28485 Ranch Road 12 New Construction

Certificate of Appropriateness Review
August 7, 2025

Proposed Building

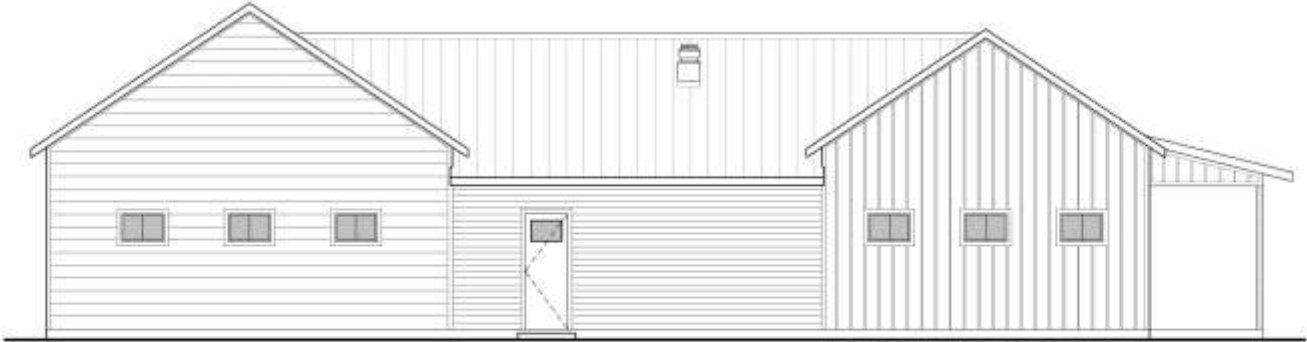
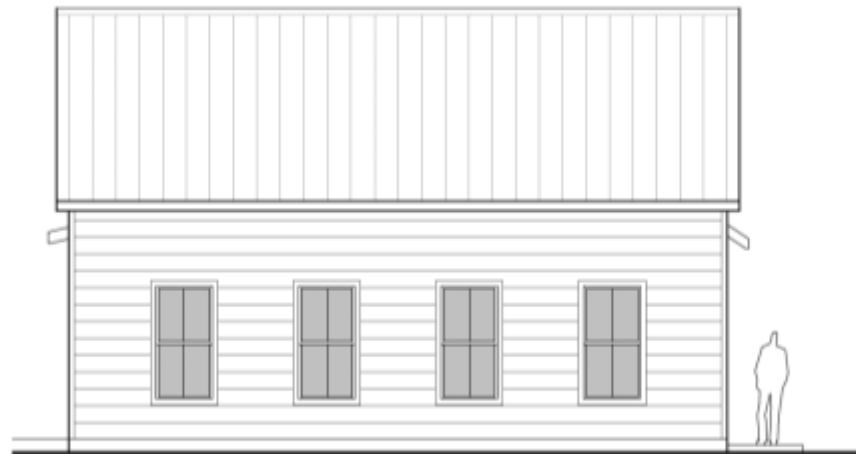
- a. The COA approval includes the revised building elevations, colors and site plan; it does not include the ice and vending machine structure shown in the plans. The applicant will be required to file a separate COA application for the ice and vending machine structure in the future.
